TARA FALLS ADDITION

Re: S/D 97-69 - Final Plat of TARA FALLS ADDITION

Re: S/D 97-69 Revised Preliminary Plat of TARA FALLS ADDITION

CASE NUMBER: S/D 97-69 TARA FALLS ADDITION

TARA FALLS ADDITION

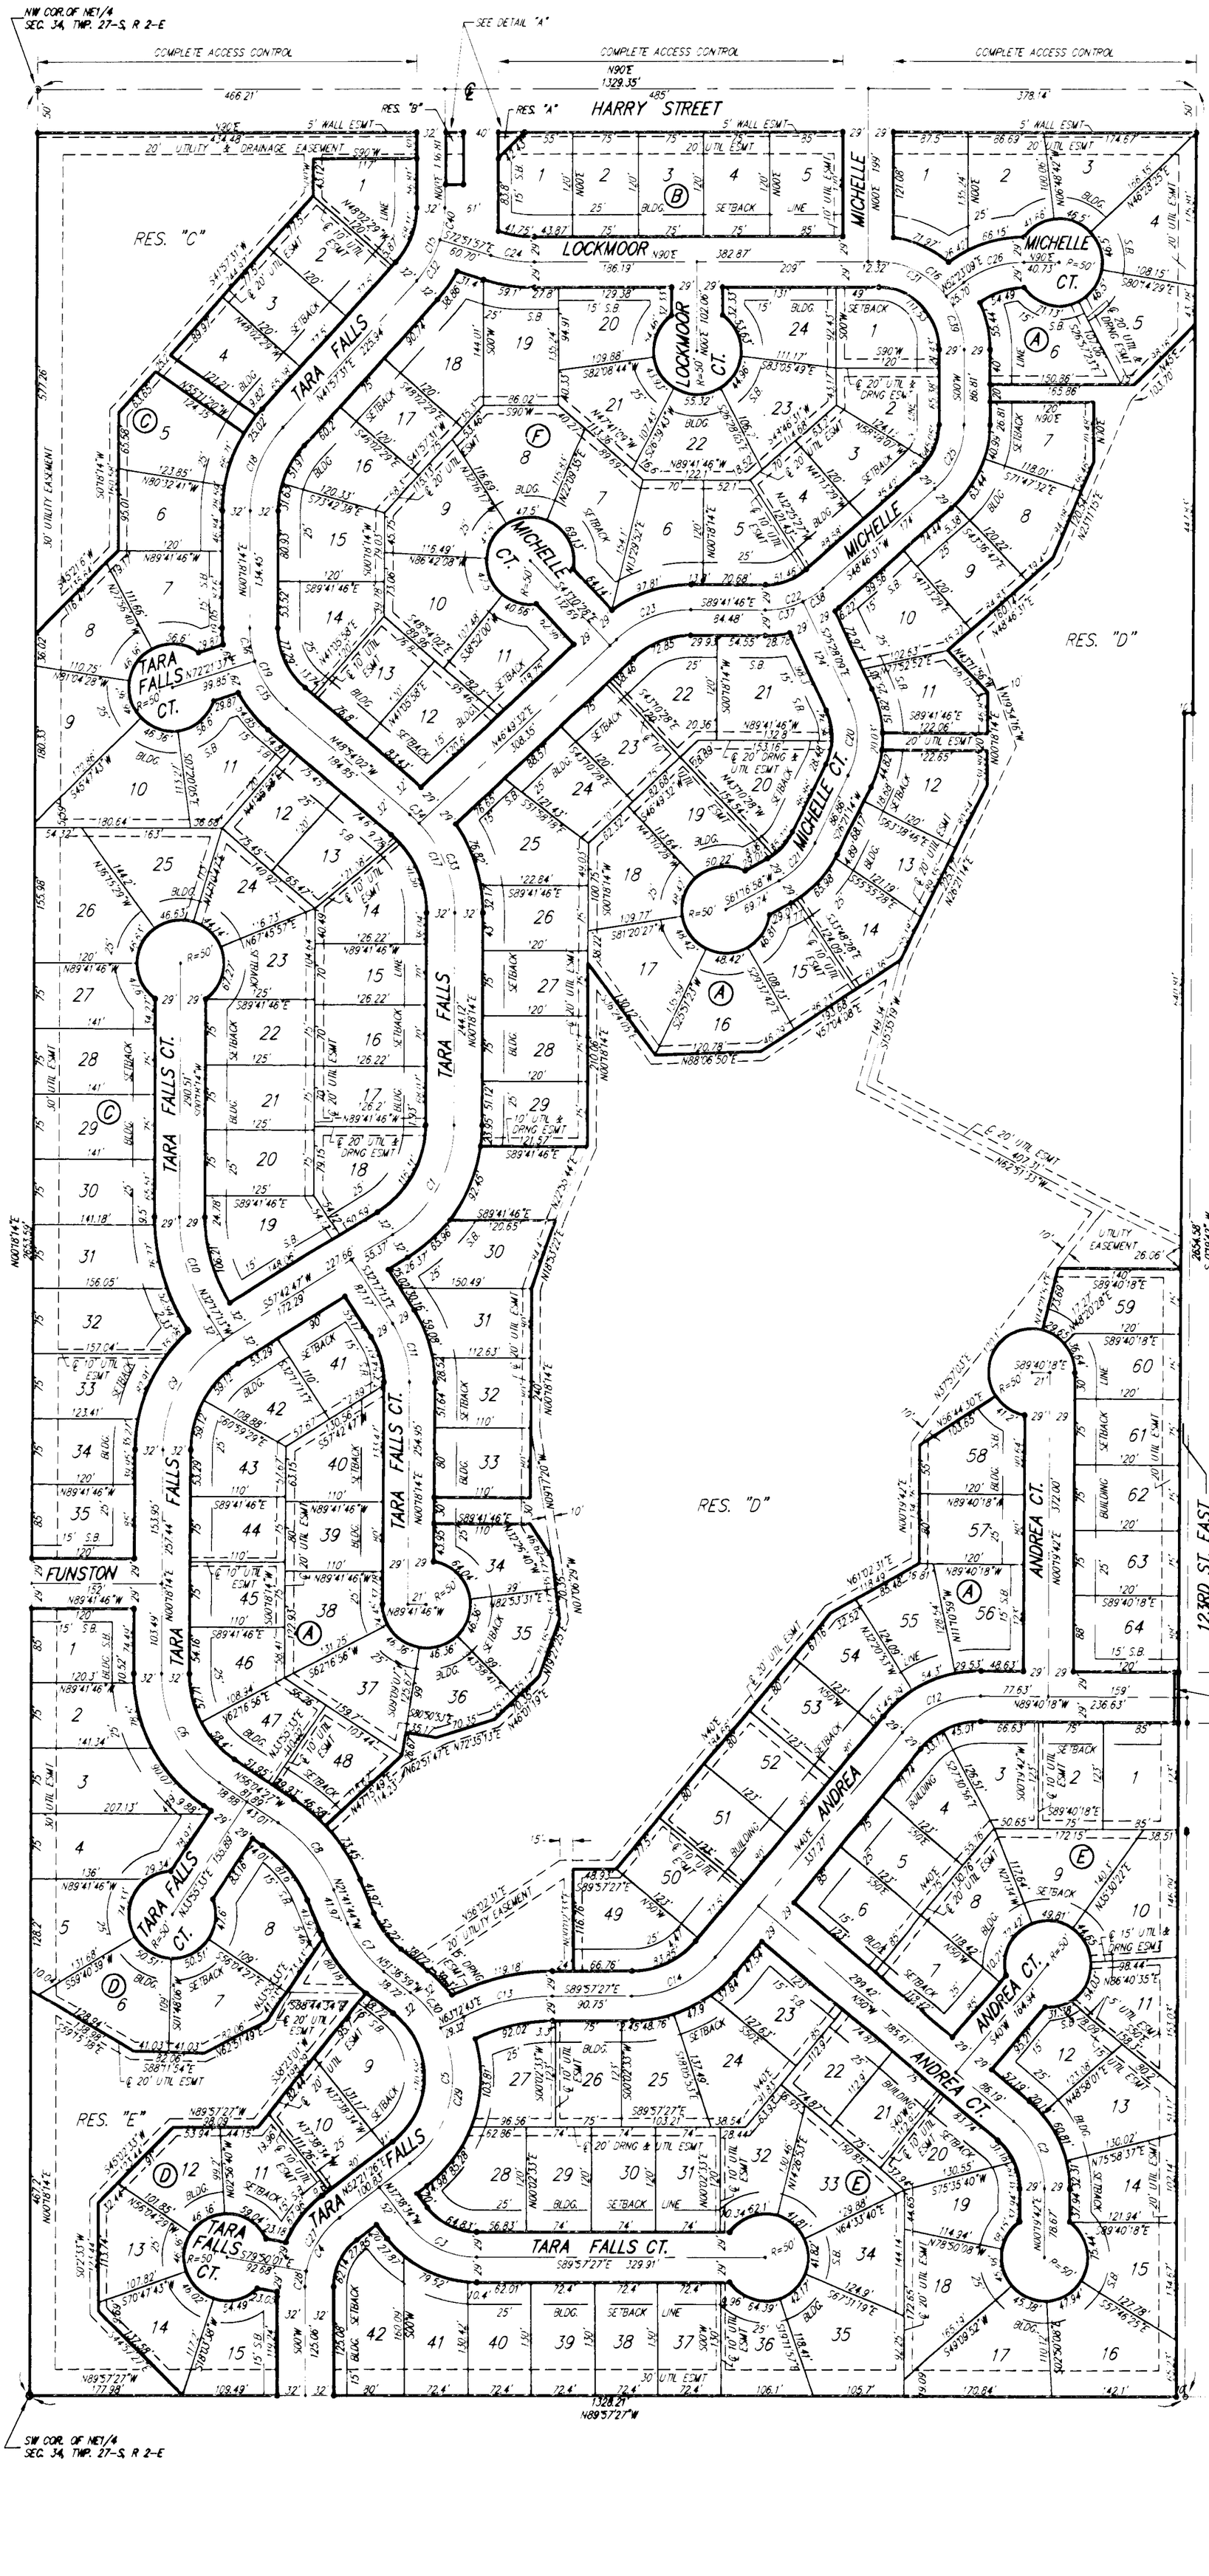
For those lots surrounding the lake, a minimum pad elevation should be shown on the face of the final plat. County Engineering needs to comment on the accuracy of the minimum building pad elevations. *The minimum building pad elevations need to be revised.*

S. The representatives from the utility companies should be prepared to comment on the need for any additional utility easements to be platted on this property. ***KG&E has requested additional easements.***

V. For any lots with existing tree rows that may be impacted by the installation of utilities, it is recommended that overly wide utility easements (30 foot) be platted in order to allow for the installation of the utilities without damage to such tree rows.

Y. The 25-ft front yard setback denoted on the lots should be labeled on the final plat tracing.

Z. The platting of wall easements needs to be referenced in the plattor's text.

As requested, the final plat has indicated 30-foot utility easements along the tree rows at the southern and western lines of the plat.
